REVISED TECHNICAL SPECIFICATION PAGES
FOR
REMOVAL OF BUS 1A and 1B LOW VOLTAGE AUXILIARY RELAYS

- References: 1) CNS Technical Specification Amendment 43, dated April 11, 1978, "Undervoltage Protection and Relays"
- 2) CNS Technical Specification Amendment 124, dated August 3, 1988, "Revised Setpoints for Undervoltage Relays"
- 3) CNS Technical Specification Amendment 144, dated July 17, 1991, "Revise Loss of Voltage Relay Settings"

Therefore, the District requests that the CNS Technical Specifications be revised to remove relays RHR & CS 27X3 1A/1B from the protective instrumentation tables 3.2.B and 4.2.B located on pages 53, 55, 70, and 71 respectively.

FIGURE 1

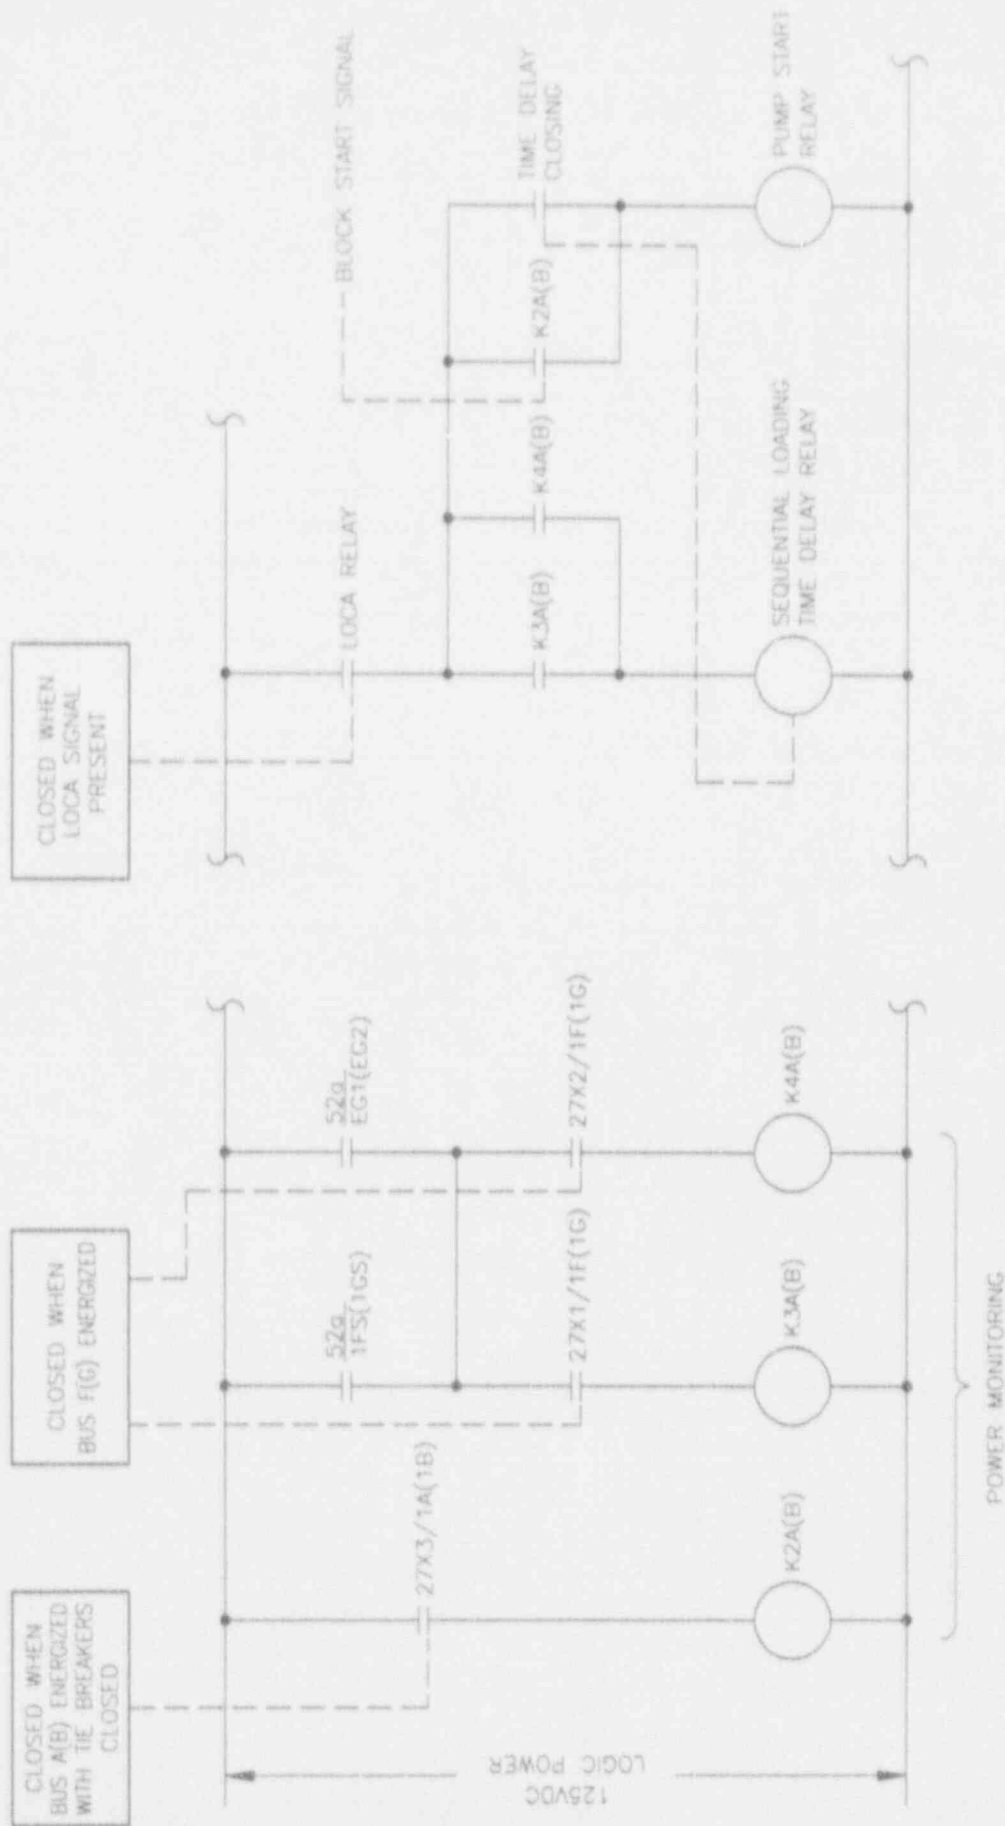
The existing alignment and safety function of the relays is discussed below. The original GE design of the RHR and CS relay logics started the RHR and CS pumps differently depending on the power source (Figure 1 attached). If the SSST source was available, the RHR and CS pumps were block started onto the SSST. If the SSST was not available, but the ESST or the EDG was available, the RHR and CS pumps were sequentially started onto either of these power sources. The RHR & CS 27X3 1A/1B relays were originally included in the licensing of CNS with their function being to energize RHR relays RHR-REL-K2A/B and Core Spray relays CS-REL-K2A/B when a first level undervoltage (Reference 3) condition did not exist (no loss of voltage) on Buses 1A and 1B with the tie breakers closed, thus powering buses 1F and 1G from the SSST (Figure 1 attached). Energizing relays RHR-REL-K2A/B and CS-REL-K2A/B would bypass the sequential loading timers and result in a block start of the RHR and CS pumps when powered from the SSST. During the Safety System Functional Inspection (SSFI) of CNS conducted in 1987, the District committed to removing the block start capability and initiate sequential loading of the ECCS pumps on the SSST to improve voltage control on the critical buses. This essentially changed the GE relay logic to initiate sequential loading of the RHR and CS pumps on the availability of the SSST, the ESST or the EDG by reconfiguring the RHR-REL-K2A/B and CS-REL-K2A/B relays from bypassing the sequential loading timers to energizing the timers (Figure 2 attached). In this configuration, the RHR & CS 27X3 1A/1B relays initiated sequential loading when buses 1F and 1G were powered from buses 1A and 1B via the SSST. In 1989, the Second Level Undervoltage

FIGURE 2

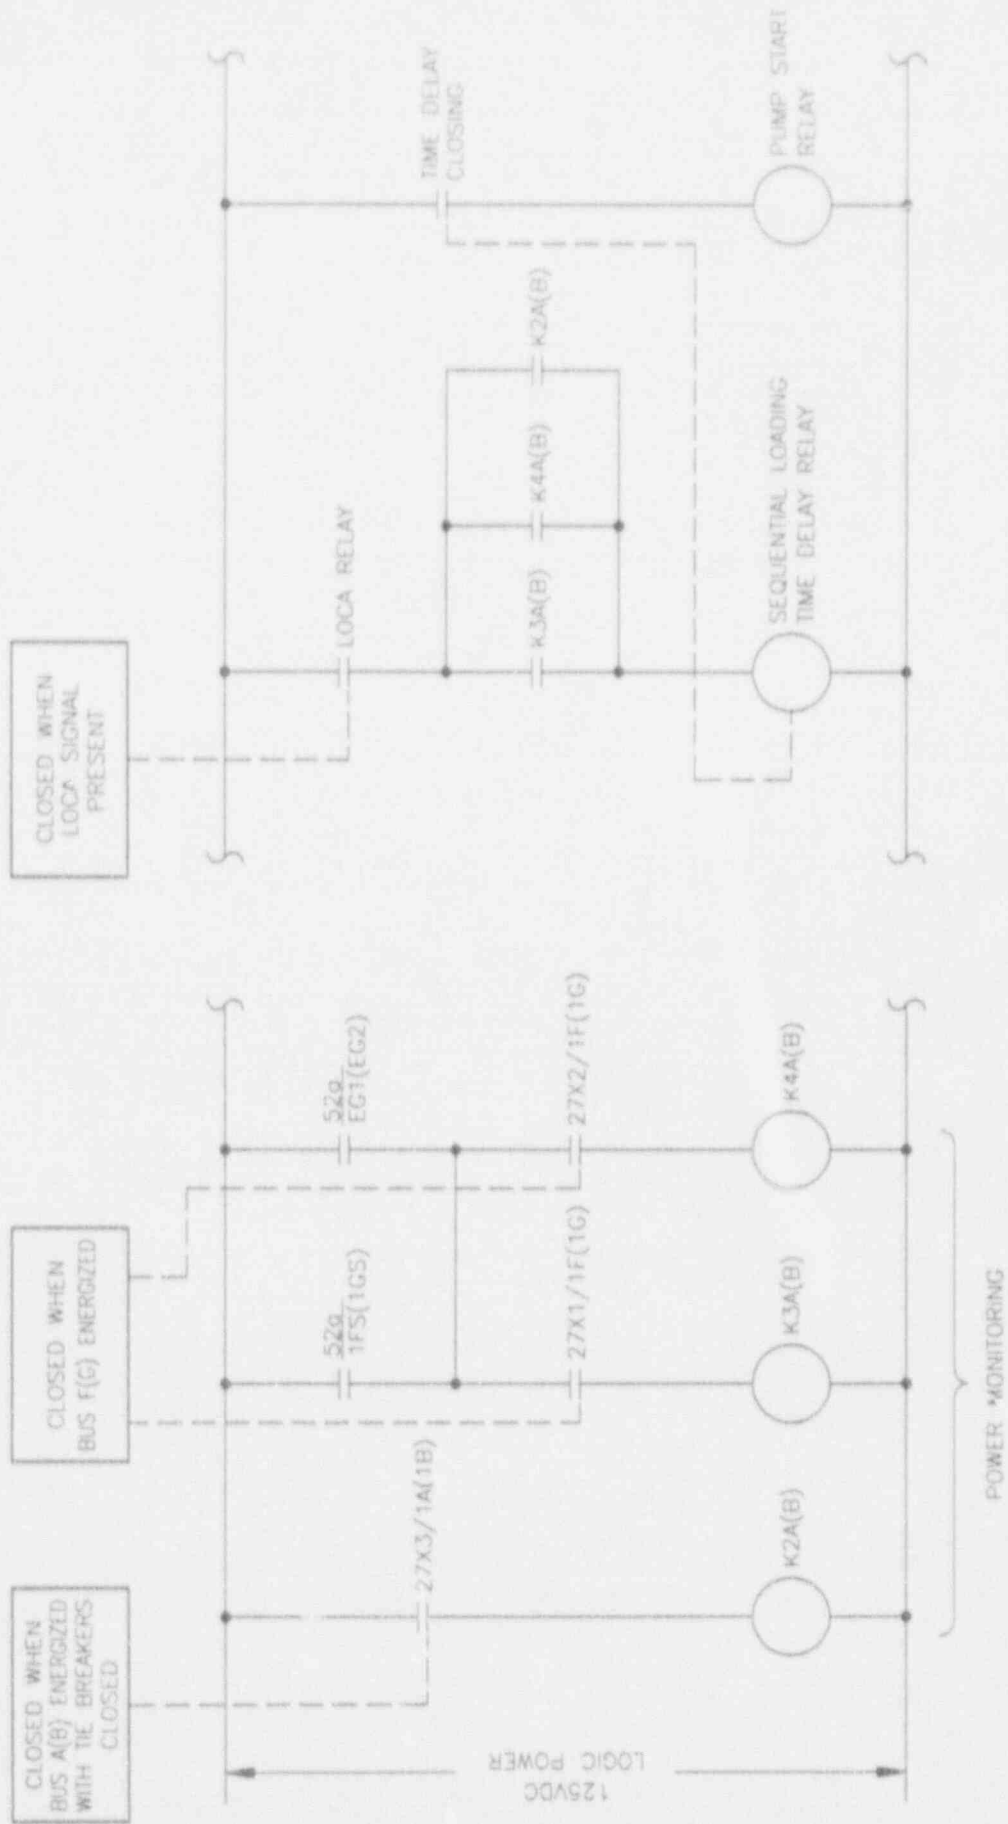
SIMPLIFIED ORIGINAL LOGIC WITH
BLOCKSTART FROM SSST

FIGURE 3

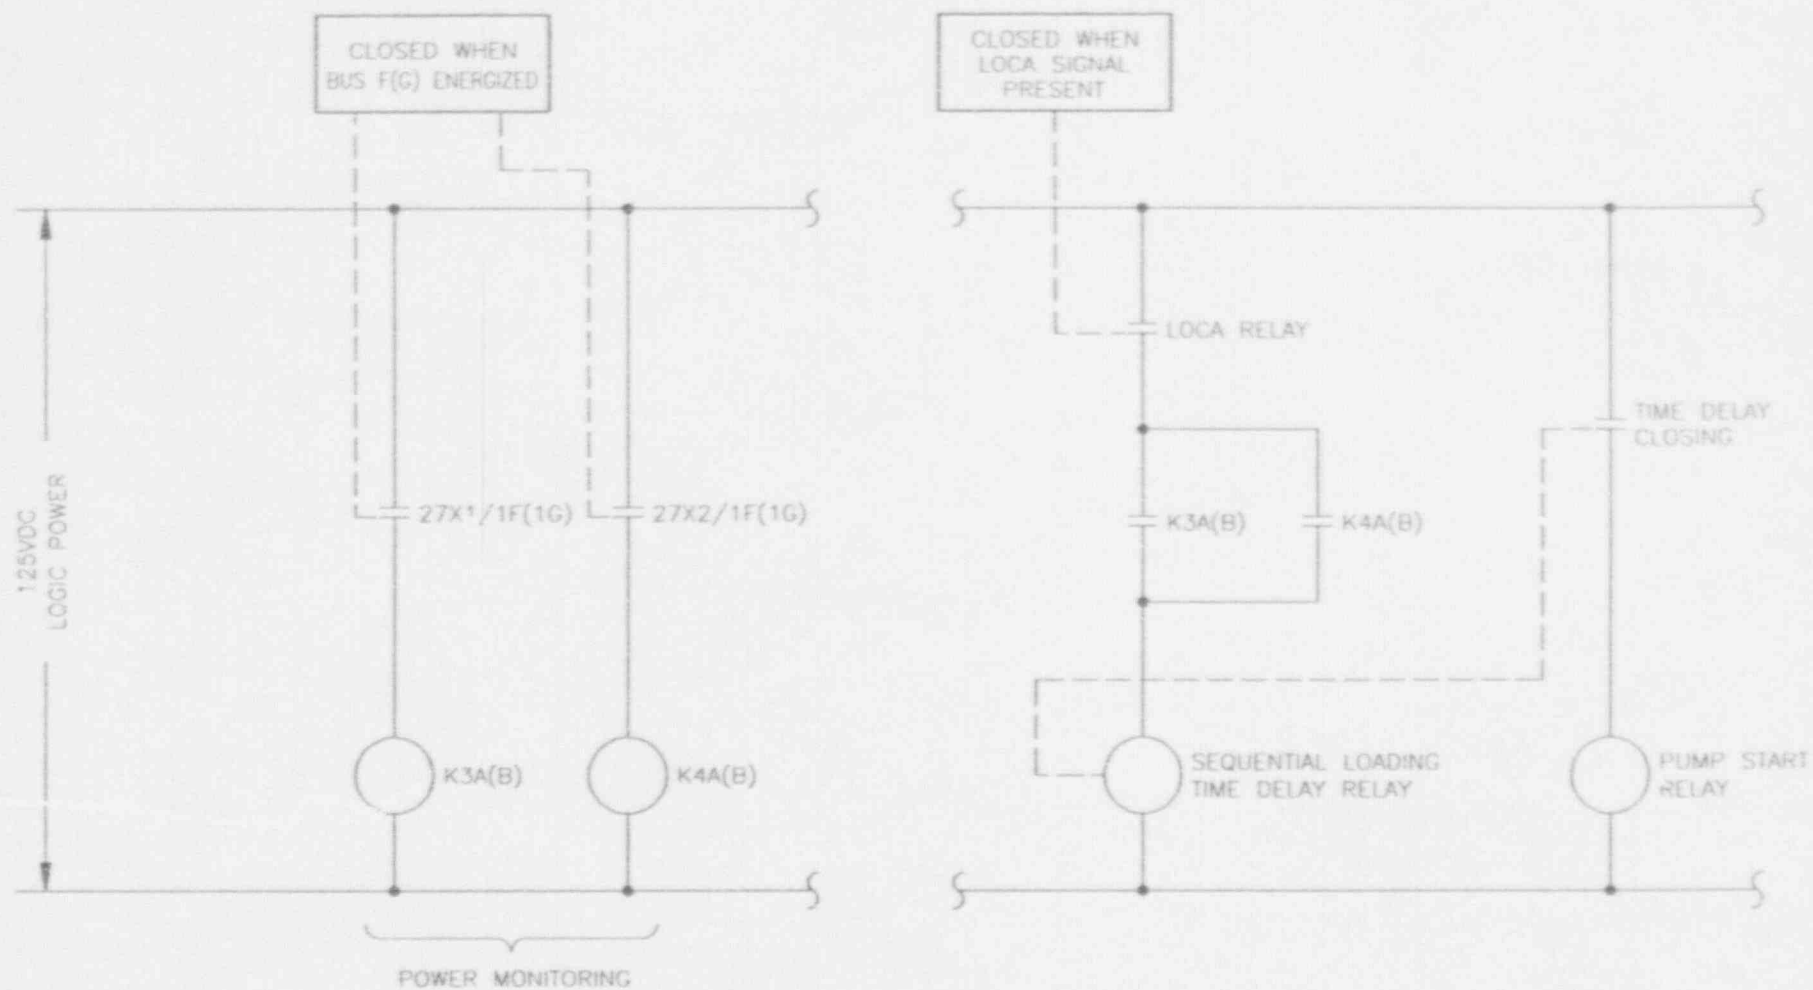
The existing RHR and CS relay logics utilize 52a contacts from breakers 1FS/1GS and EG1/EG2 in the RHR and CS pump start logic. The RHR and CS relay logic will be modified to perform the same safety function without the breaker 1FS and 1GS interlocks. The existing 52a contacts from breakers EG1 and EG2 (emergency diesel generator breakers) will also be removed without changing the safety function. The removal of the 1FS, 1GS, EG1, and EG2 52a contacts will simplify the RHR and CS pump start circuitry while providing the same safety function. With these contacts removed, the power monitoring logic of the RHR and CS logic continues to provide a sequential start of the RHR and CS pump motors when adequate voltage is available on Buses 1F and 1G (Figure 3 attached). The modification will simplify the RHR and CS relay logic, by removing a component in the logic scheme, and will not change the desired performance of the RHR, the CS or the EE systems.

SIMPLIFIED PROPOSED LOGIC WITH
27X3/1A(1B) RELAYS REMOVED
